Review and Refinement of ATC 3-06 Tentative Seismic Provisions

Report of Joint Committee on Review and Refinement

NBSIR 80-2111-11

REVIEW AND REFINEMENT OF ATC 3-06 TENTATIVE SEISMIC PROVISIONS

Fig. A - Reinforcement Details
Satisfying Section 11.4.1 (E)

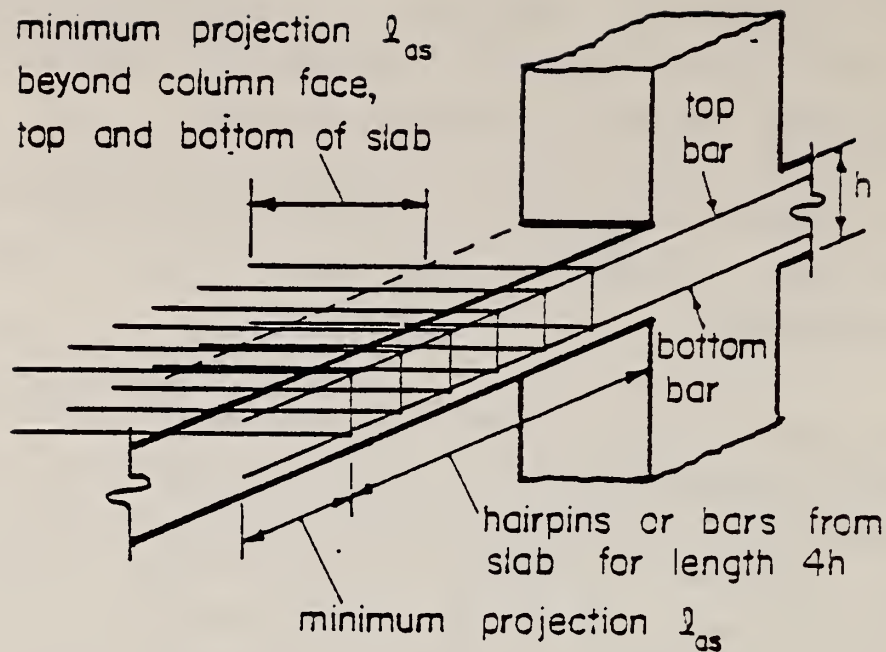
As shown in Fig. A there should be top and bottom bars in the slab paralleling and as close to the discontinuous edge as possible, continuous through the column and enclosed within transverse reinforcement having a spacing not greater than $0.5d$. The transverse reinforcement can be closed hoops, hairpin stirrups projecting l_{as} beyond the face of the column as shown in Fig. A or slab bars bent to satisfy the requirements for hairpin.
